**SWITCHING SINGLE LINE DIAGRAM**  
**AL KHARJ NEW 132/33/13.8KV S/S • 8716**  
**MILITARY INDUSTRIES**

132kV GIS LCC  
SCHEMATIC DRAWINGS

SUBSTATION 8716

SEC-COA 132kV/33kV/13.8kV SUBSTATION #8716  
 GAS SCHEME DIAGRAM  
 LCC SCHEMATICS FOR D01 NO.2 TR.(GT2) BAY  
 ALKHARJ SAUDI ARABIA

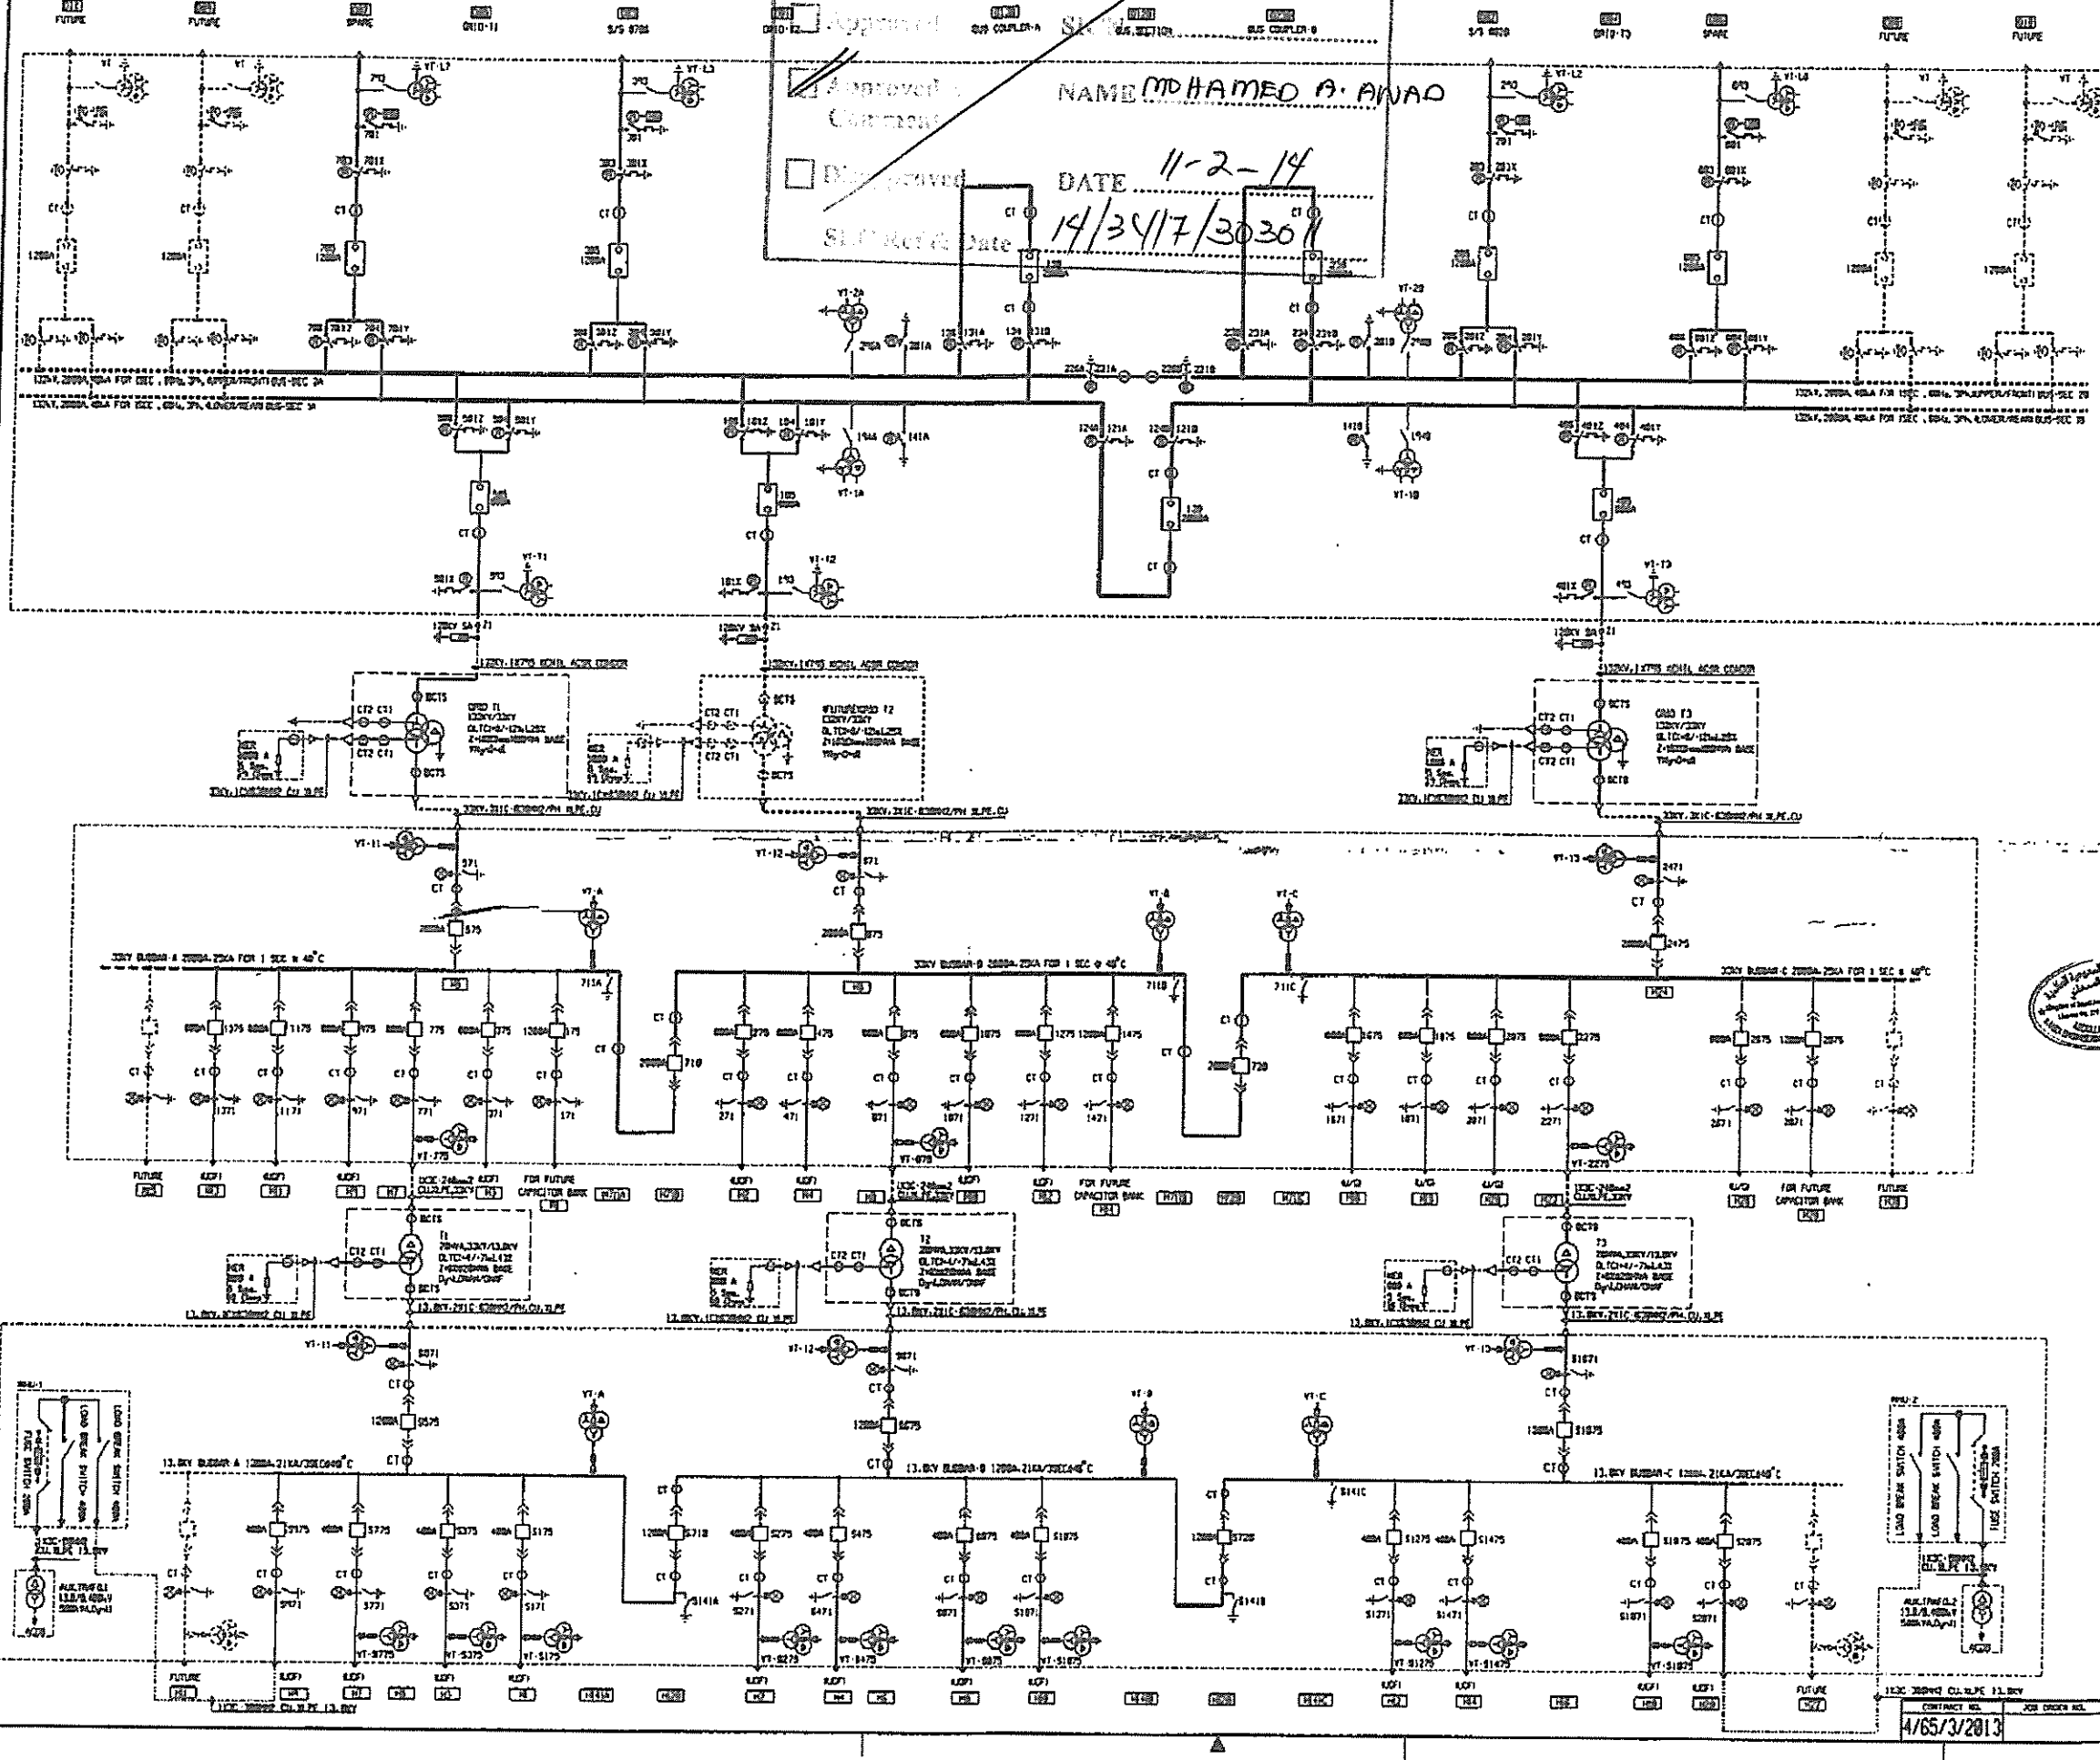
Comments: Interlock Table shall be submitted to review / approval
